Before modification (VDD11→VDD33)

After correction (VDD33→VDD11)

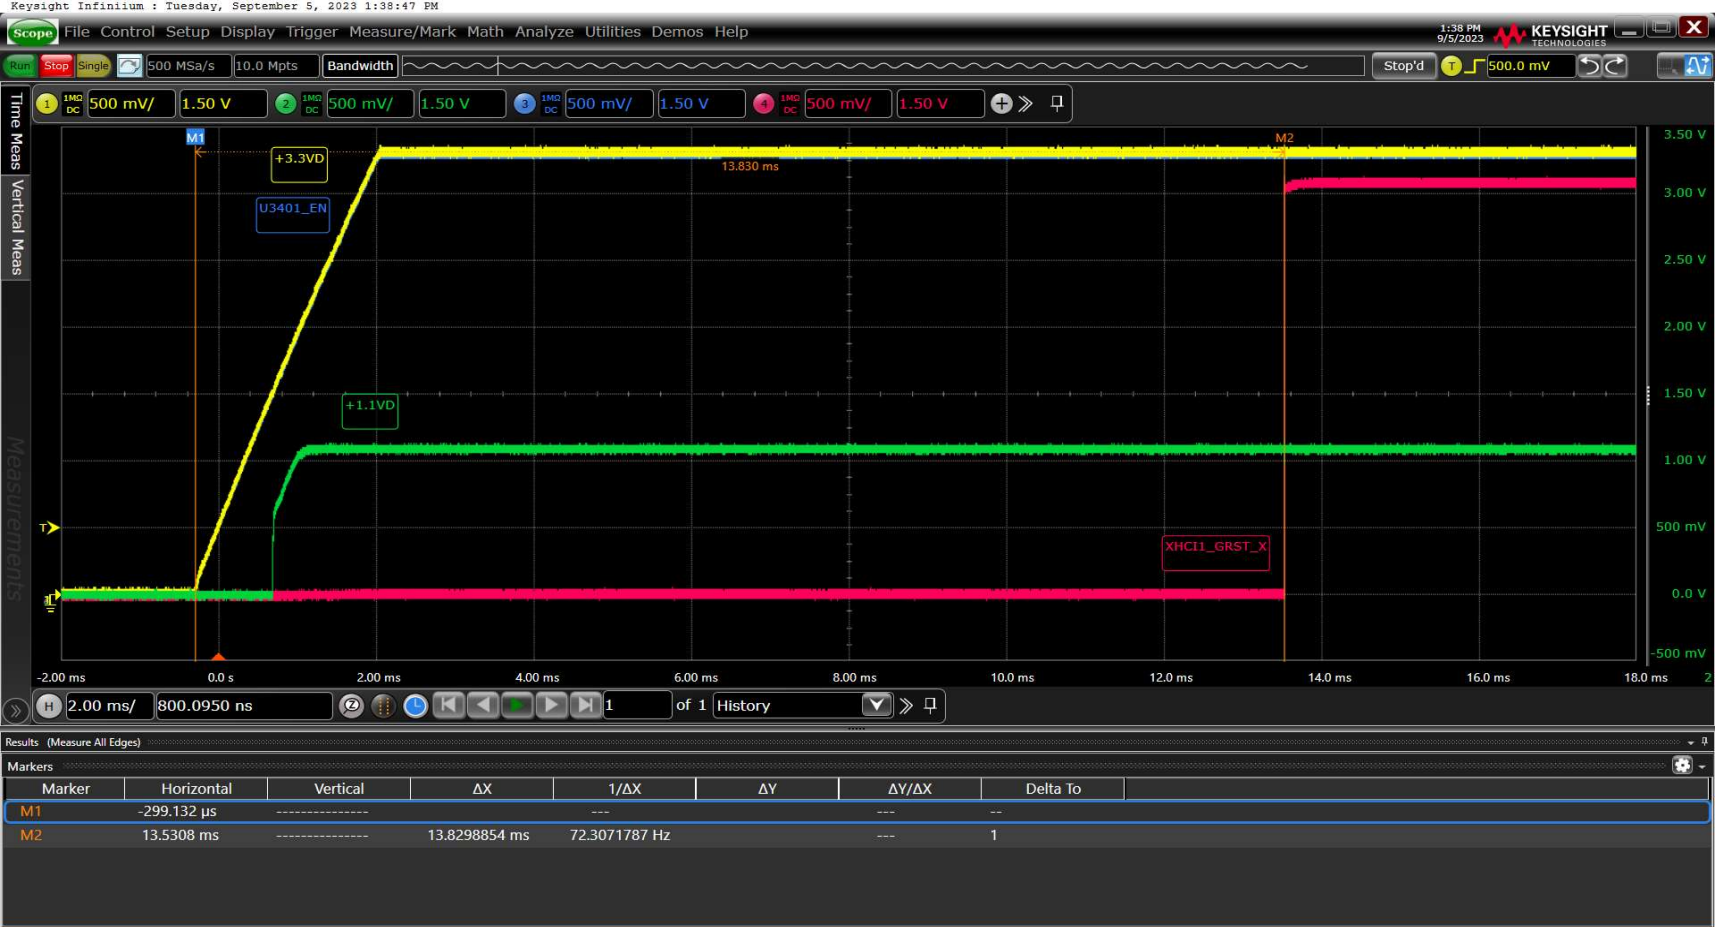
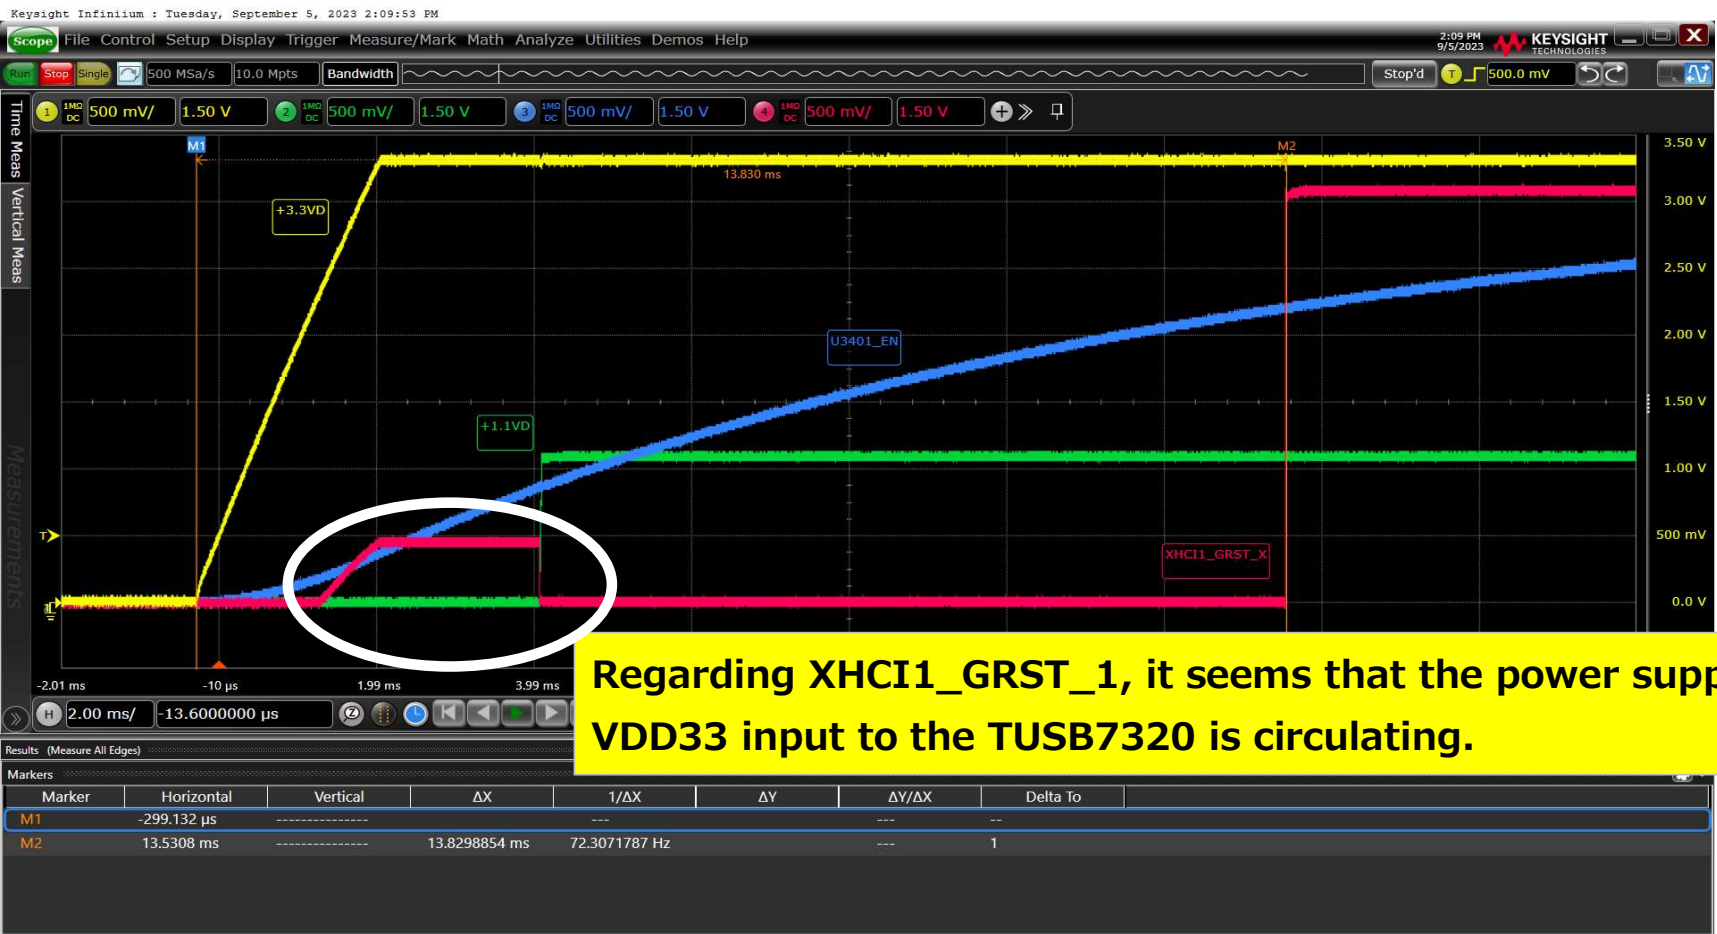
Regarding XHCI1_GRST_1, it seems that the power supply of VDD33 input to the TUSB7320 is circulating.
